FIELD SERVICE CAMPAIGN – 21110R1

Auxiliary Heater (ESPAR) Disable Signal

International® LT®, LoneStar® and HX® Series trucks with International® A26 or Cummins® X15 engine

Updates to images and procedure for additional clarity.

Figure 2. Body Control Module (BCM) Harness and Connectors

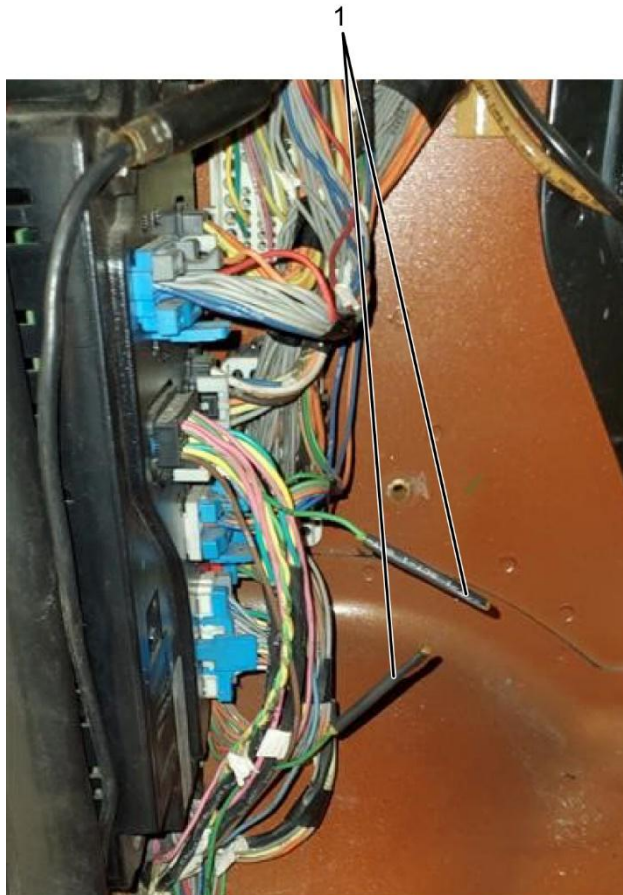
11. Find terminal L from BCM connector J6 (Figure 2, Item 2). Refer to the appropriate circuit diagram for detailed information.

12. Cut wire from terminal L, BCM HVAC Heater Enable Status ON / OFF wire, 5 inches (12.7 cm) away from BCM connector J6.
